**Title: STAGE 1 ROAD SAFETY AUDIT INCLUDING
QUALITY AUDIT**

**For;
Newtownmoyaghy SHD, Kilcock.**

Report reference: 0679R01

3.1 Problem

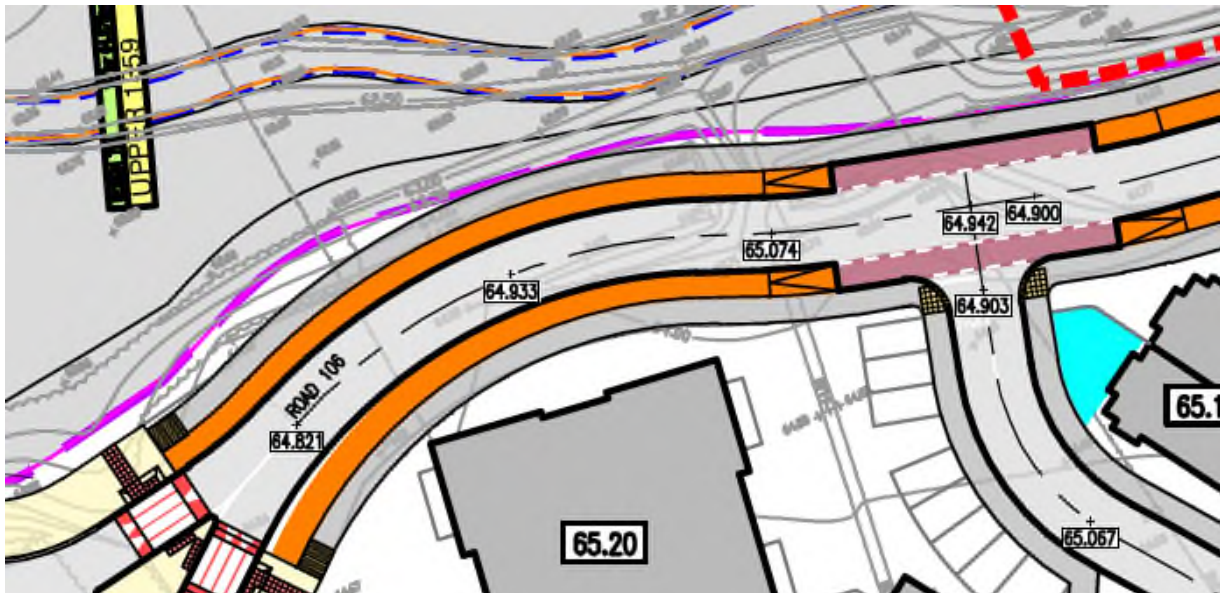
It is unclear on Road 106 to the East of the internal roundabout if the cycle track is to be vertically segregated from the footway between junctions. Without segregation pedestrian may stray into the footway and be at greater risk of being struck by cyclists.

It is recommended that the cycle track be vertically segregated and at the detailed design stage that the correct ladder and tramline tactile paving layout be provided at all areas where the two merge as a shared use area.

4.2 Problem

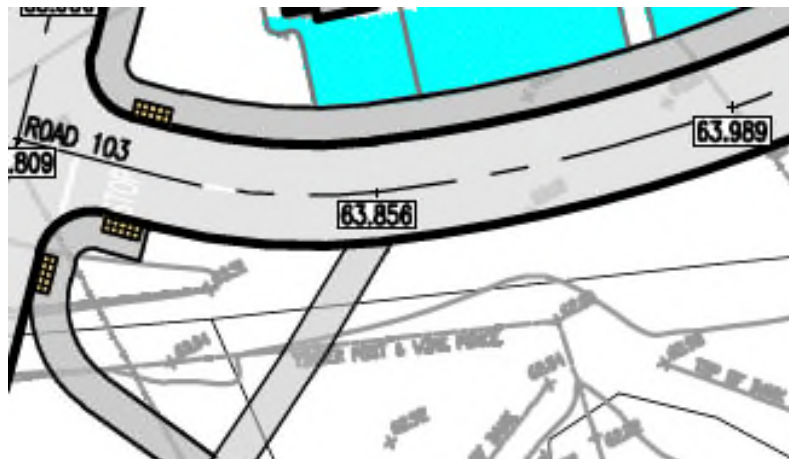
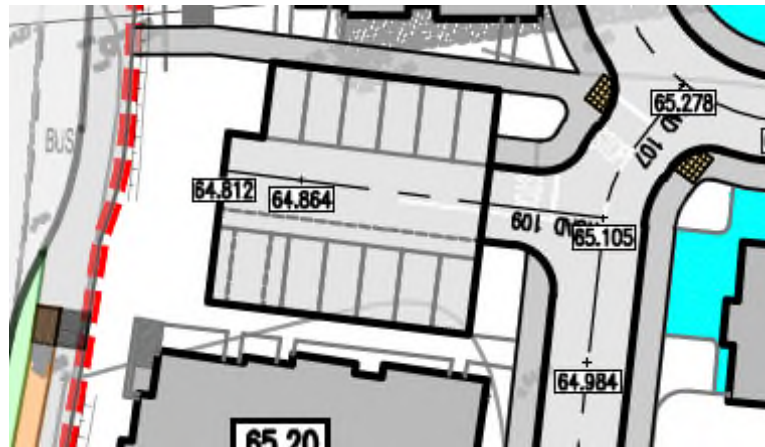
No pedestrian crossing points have been provided at some footpath junctions. For example the junction of Road 109 and Road 107. This could lead to triops and falls for pedestrians.

It is recommended that dropped kerbs and tactile paving is provided at all internal pedestrian crossing points.

4.3 Problem

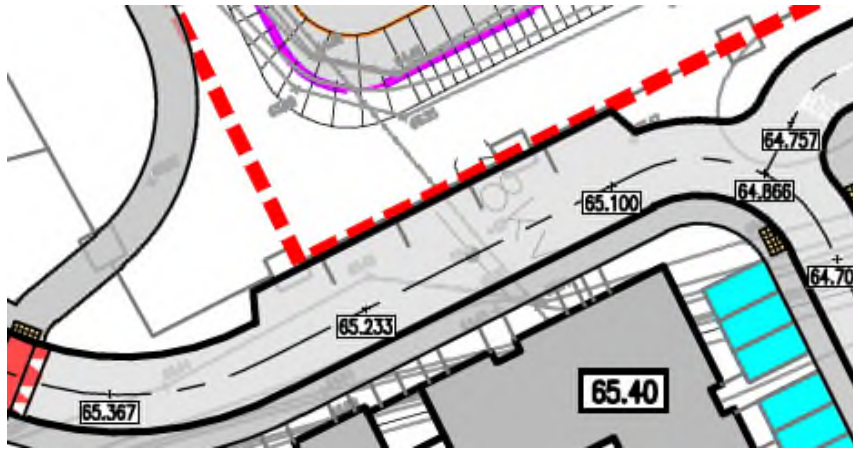
There is no hard standing to the rear of the parallel parking spaces on Road 105. This could lead to slips and falls for vehicle occupants leaving their vehicle on that side, especially during wet conditions.

It is recommended that a footpath be provided to the rear of the parking spaces.

4.8 Problem

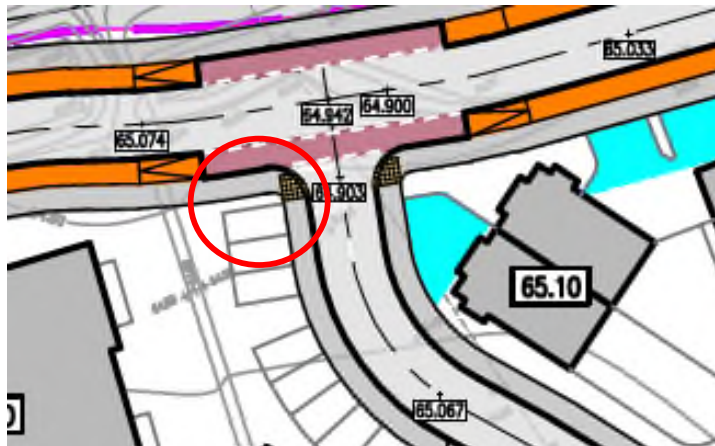
The first parking space on Road 101 at the junction with Road 106 is very close to the junction. A driver who is reversing out of this space will have to be alert of traffic turning from Road 106 and may not see a pedestrian behind the car.

It is recommended that the parking space be removed/relocated.

4.10 Problem

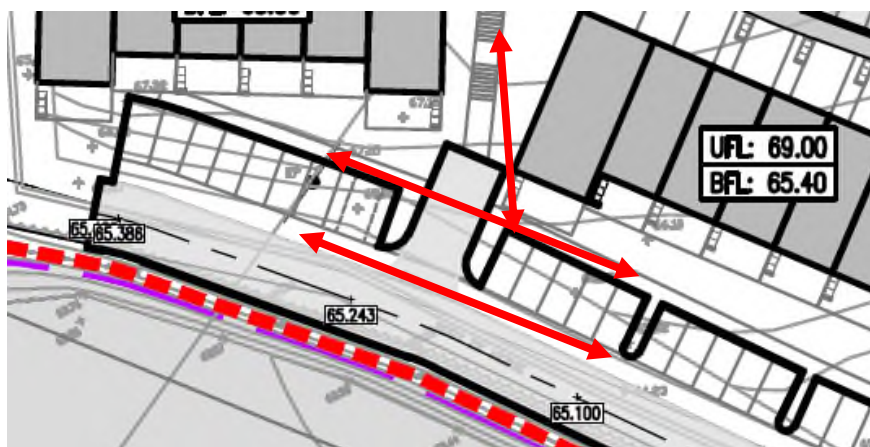
The footpaths on the northern side of Road 212 are not shaded. It is unclear if there are continuous pedestrian facilities along the front and rear of the perpendicular parking bays. The turning head may also truncate pedestrian routes.

It is recommended that the footpath network be clearly defined and that it is without discontinuities and pinch points.

4.11 Problem

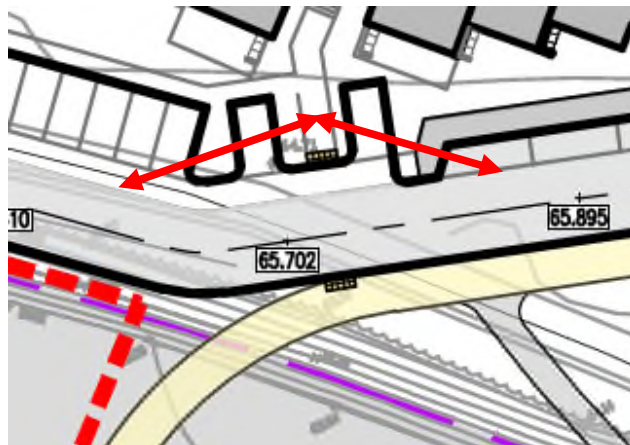
There may be a lack of inter-visibility between pedestrians and drivers at the informal crossing to the shared use track at Road 212 due to the presence of vehicles in the perpendicular parking spaces.

It is recommended that the visibility be checked and if necessary, the parking spaces be relocated.

4.13 Problem

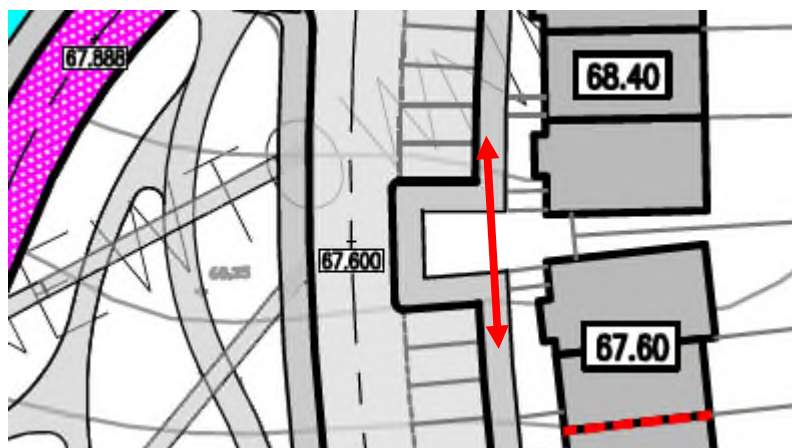
There is a footpath along the western side of Road 201 at a buildout between perpendicular car parking spaces that does not represent the desire lines for pedestrians. This will lead pedestrians to travel over the landscaped area instead.

It is recommended that the footpath be provided along the desire line.
